Public Service of New Hampshire
New Hampshire Yankee Division

SBN- 1154
T.F. B7.1.3

Subject: FSAR Revisions

ATTACHMENT 1
FSAR Revisions
(Seabrook Station)

REFUELING WATER STORAGE TANK

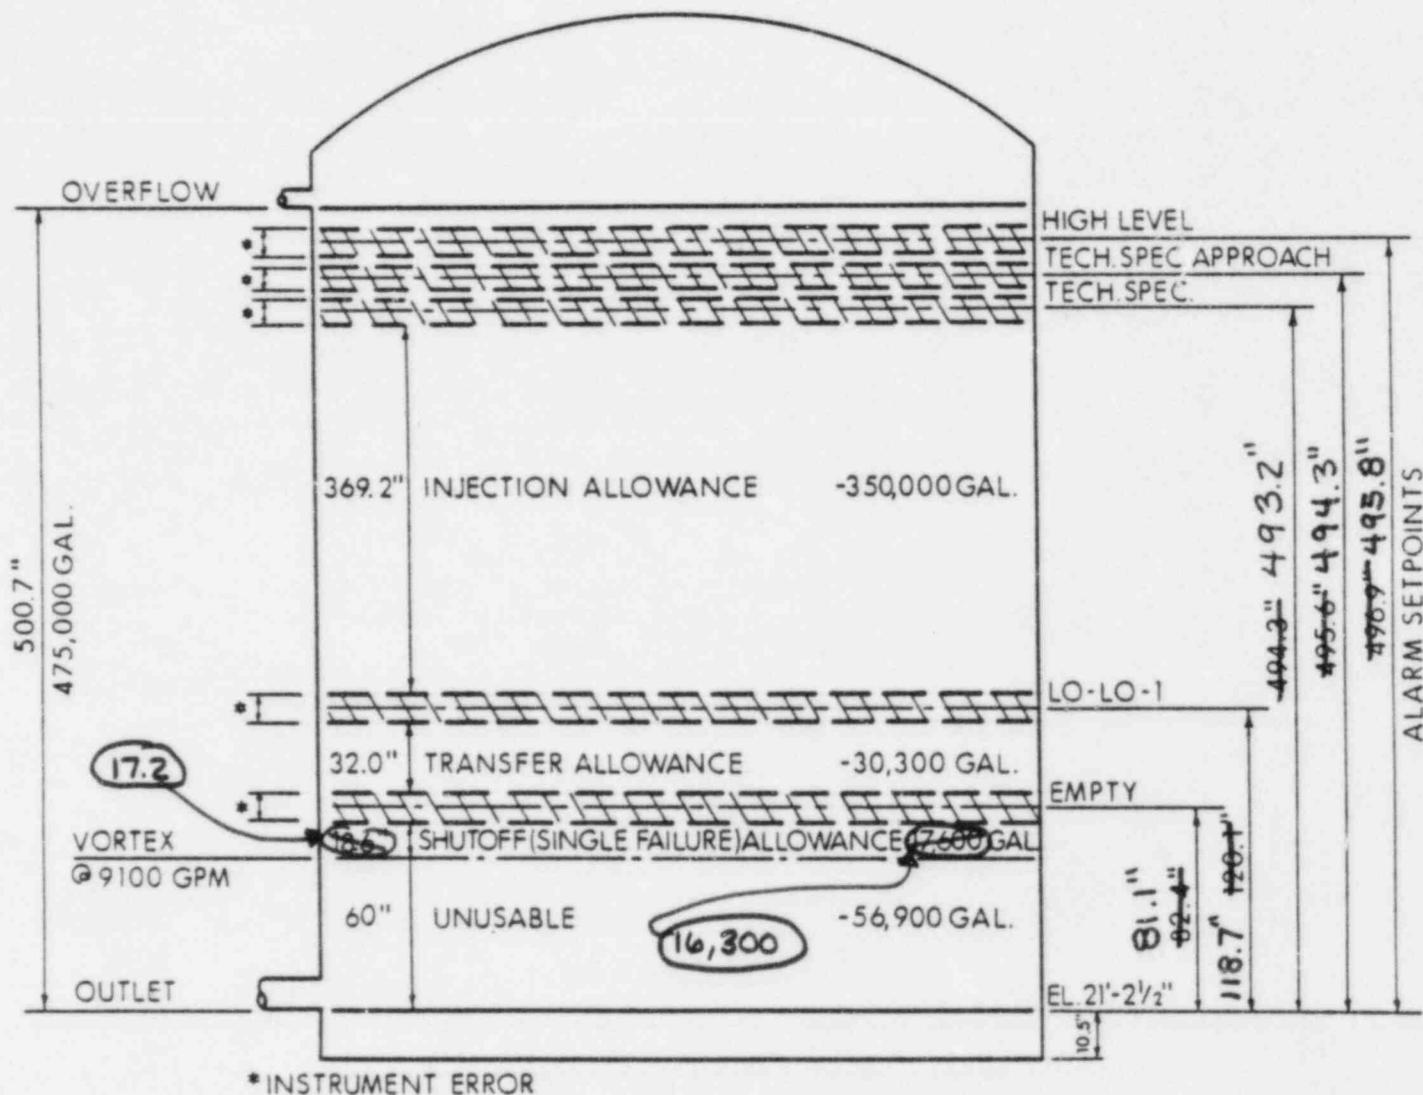
As can be seen in Figure 6.3-6, the 350,000 gallon injection allowance is contained between the extreme low range of the "tech spec" alarm error band and the extreme upper range of the "lo-lo-1" signal error band. The 30,300 gallon transfer allowance is found between the low range of the "lo-lo-1" alarm and high range of the "empty" alarm. A ~~17,000~~ gallon pump shutoff allowance is provided between the low range of the "empty" alarm and the calculated level for potential vortexing assuming the worst single failure.

16,300
